# **Relicensing Study 3.3.1**

## **CONDUCT INSTREAM FLOW HABITAT ASSESSMENTS IN THE BYPASS REACH AND BELOW CABOT STATION**

### **Initial Study Report Summary**

**Northfield Mountain Pumped Storage Project (No. 2485)  
and Turners Falls Hydroelectric Project (No. 1889)**

**Figure 1: Habitat Suitability Index, Sea Lamprey- Spawning & Incubation**  
**Species: Sea lamprey**  
**Lifestage: Spawning and Incubation**

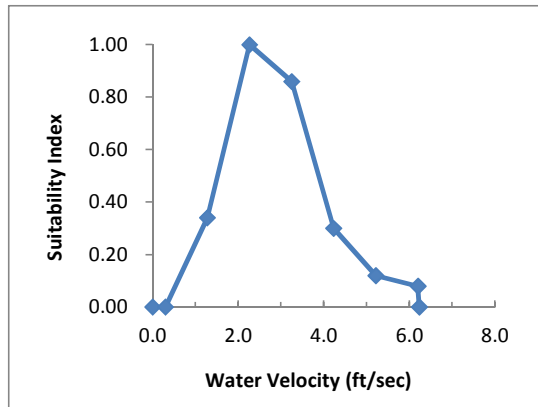
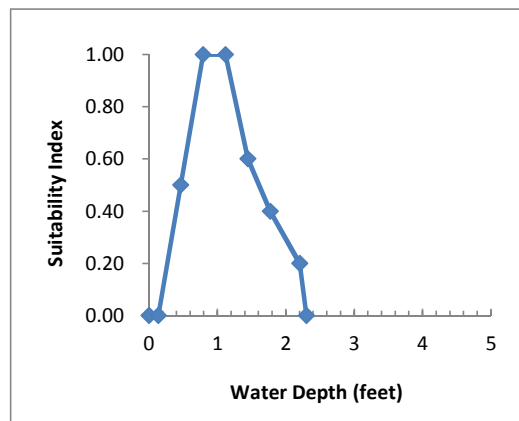
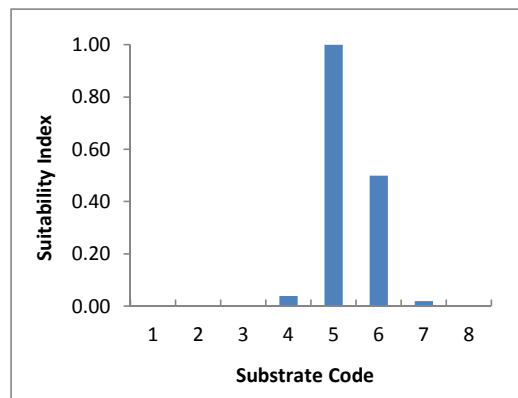
- *Habitat Suitability Index (HSI) Development for Sea Lamprey*: FirstLight revised the HSI criteria for sea lamprey as recommended by USFWS, attached as [Figure 1](#).

Source: Habitat Suitability Index for Sea Lamprey redds  
 Kynard and Horgan 2013  
 Revised depth and substrate per USFWS July 3, 2014 letter, extrapolated from Yergeau, 1983

**Turners Falls IFIM Study  
Reach 3 Logger Locations  
Upper Part of Reach 3**

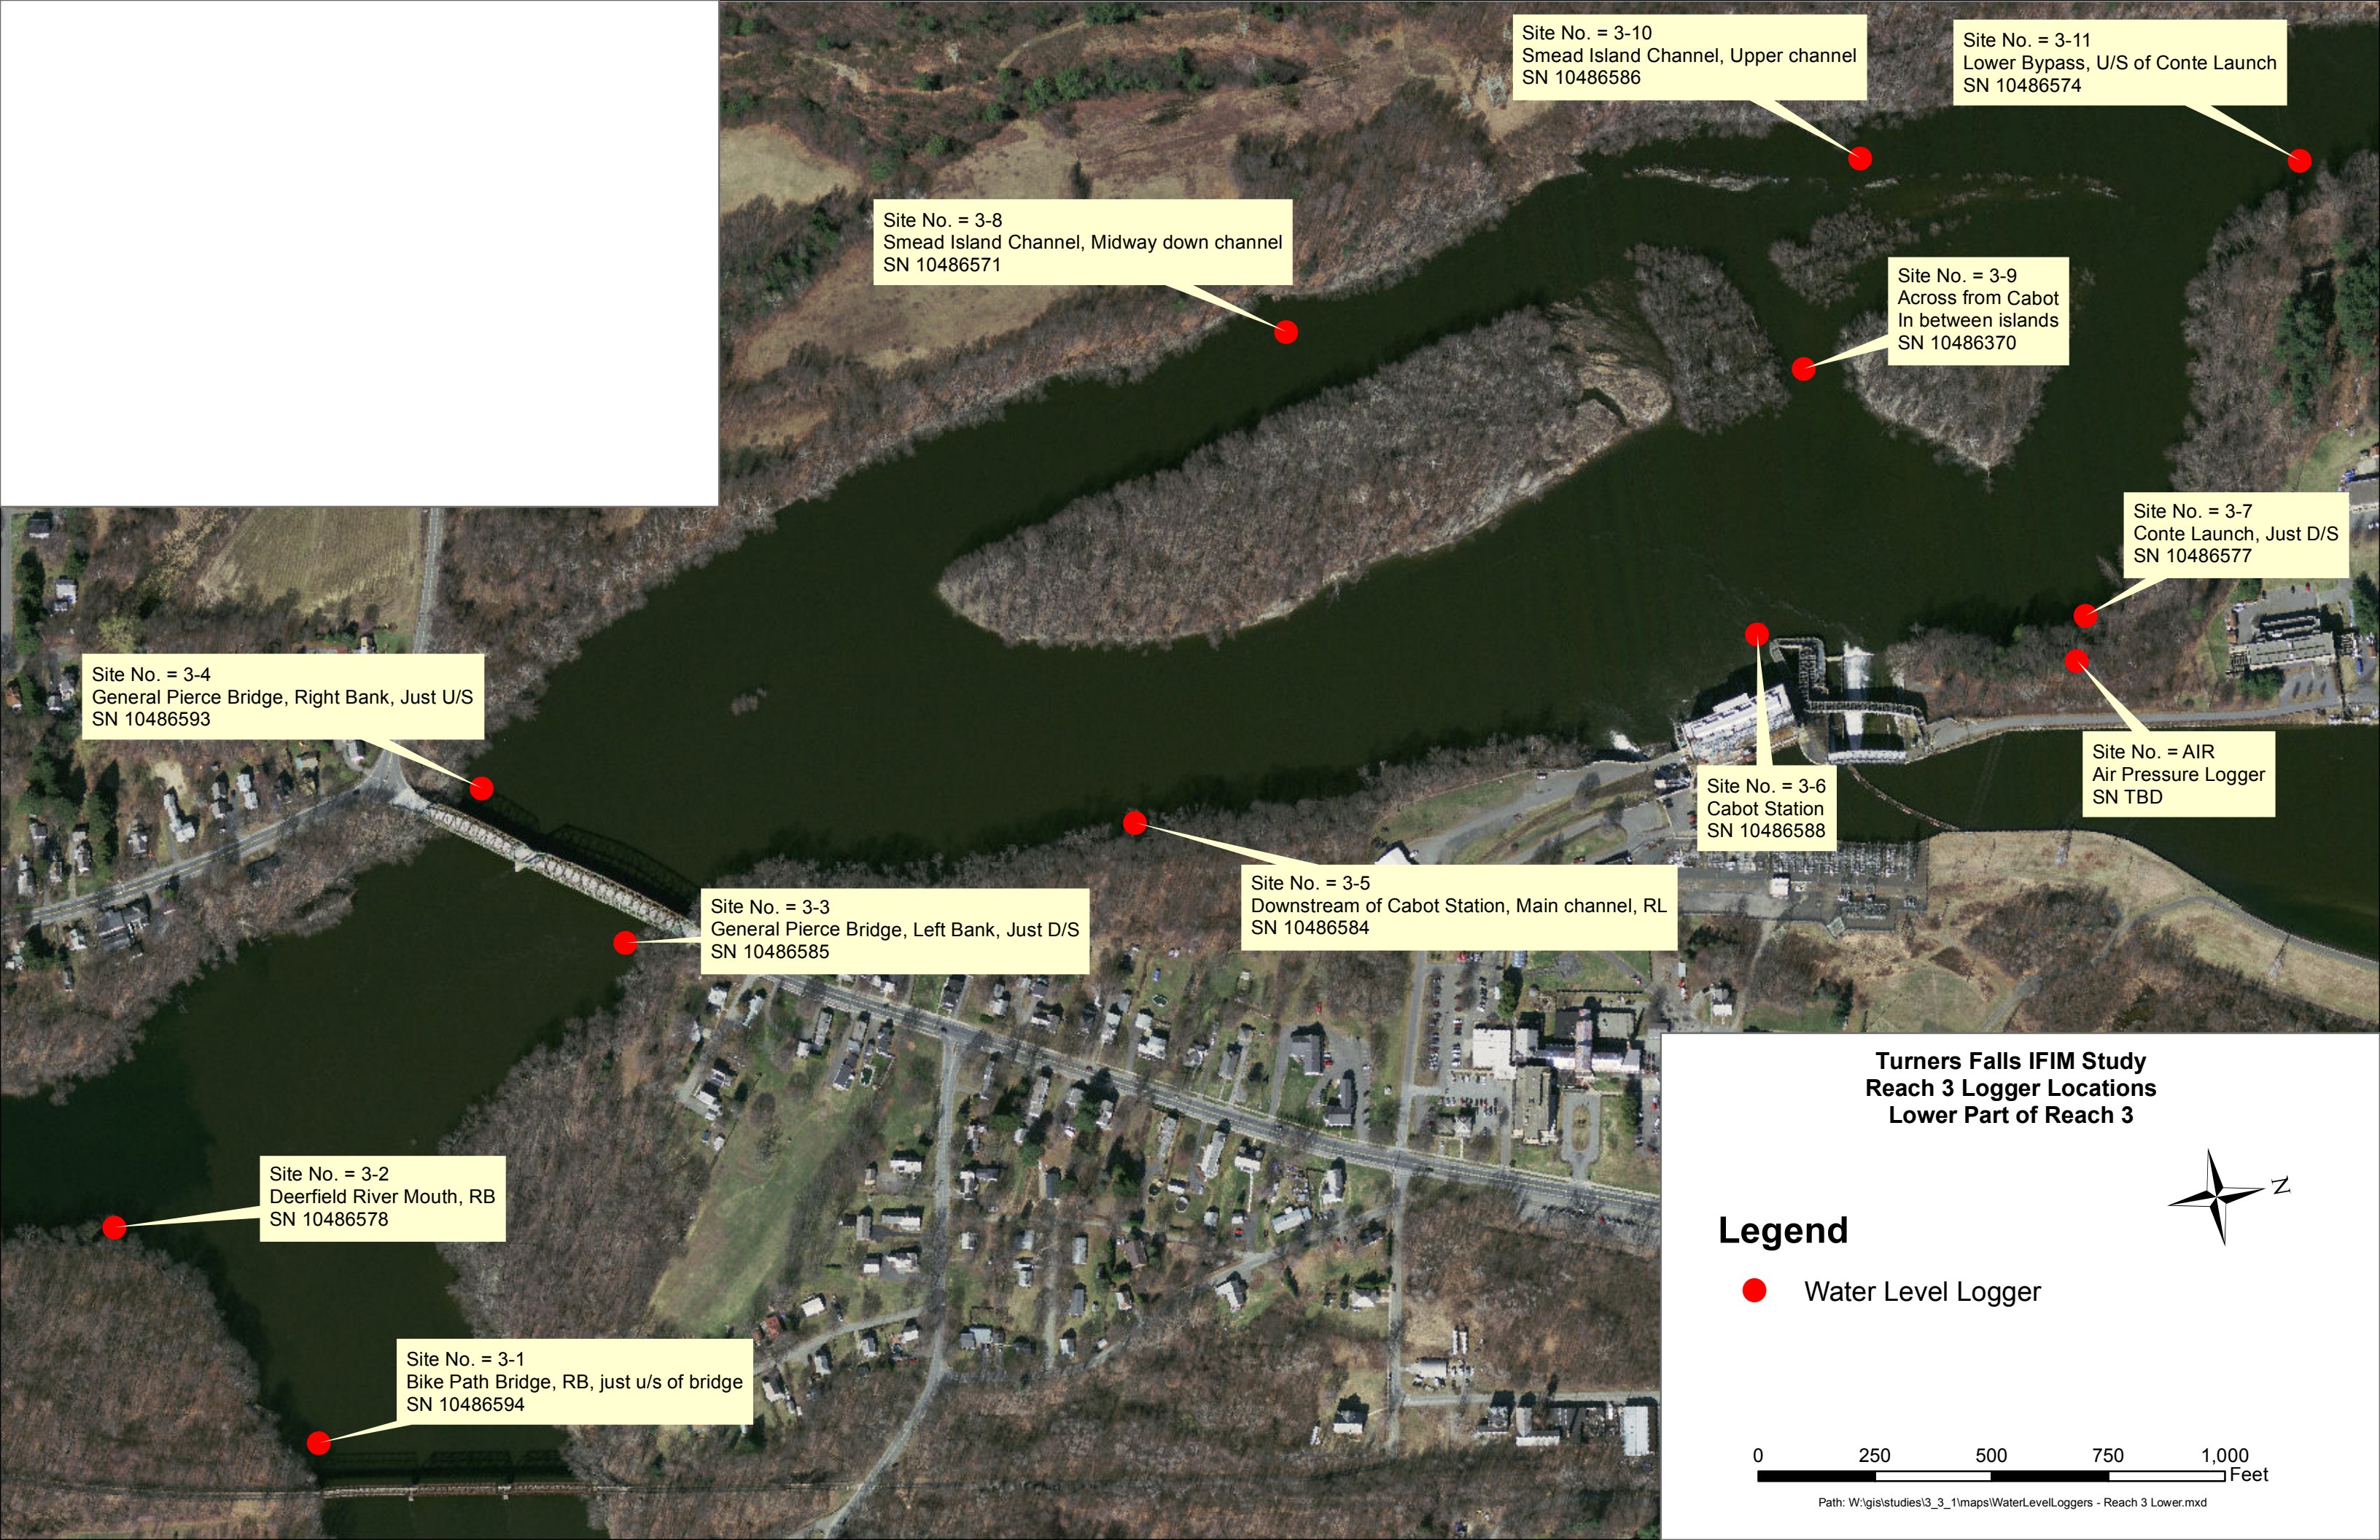
- Site No. 3-5 could be moved upstream about 250 feet to capture the middle between Cabot and the General Pierce bridge. I don't have a map of the sturgeon spawning areas, but certainly those areas should be targeted.
- Or possibly add a logger on the eastern bank of Smead Island in the middle of the island.

Lower part of reach 3 logger locations: <ul style="list-style-type: none"><li>Site No. 3-5 could be moved upstream about 250 feet to capture the middle between Cabot and the General Pierce bridge. I don't have a map of the sturgeon spawning areas, but certainly those areas should be targeted.</li><li>Or possibly add a logger on the eastern bank of Smead Island in the middle of the island.</li></ul>	The hydraulic model being developed for Reach 3 will cover the entire reach. Reach 3, including the sturgeon spawning area, will be evaluated using the 2-D model. In addition to the water level loggers we have already placed, the velocity calibration and validation data collection efforts will result in water surface elevation information throughout the reach.
<b>Thomas Chapman, USFWS: July 3, 2014</b>	
Coding Bedrock Substrates - The proposed bedrock coding is acceptable.	FirstLight concurs.
Reach 1 Empirical Assessment Methodology The Service has concerns with FirstLight's proposed methodology for Reach 1 and recommends identifying polygons to represent the different habitats in that reach and then locating a transect in each of those polygons, thus allowing calculation of a Weighted Usable Area (WUA) for that habitat at a given flow. Slides were provided to suggest a method to identify different habitat polygons which then theoretically would each have a transect placed in them, allowing for an approximate calculation of area for each habitat and therefore a WUA-to-flow relationship.	First Light is open to the USFWS's more quantitative approach as an option. However, keeping in mind that the goal of the flow demonstration is to empirically evaluate potential flow recommendations based on outcomes from the PHABSIM model conducted further downstream, a consequence would be that the requested quantitative results would not be available to flow demonstration participants until well after the flow demonstration. This is because WUA data will need to be computed and processed and reported (an office exercise). Thus, this type of decision information would not be available at the time that the participants are observing the demonstration flow. However the decision whether or not to adopt this approach can be collaboratively determined by consensus of the assessment team at the time of the flow demonstration.
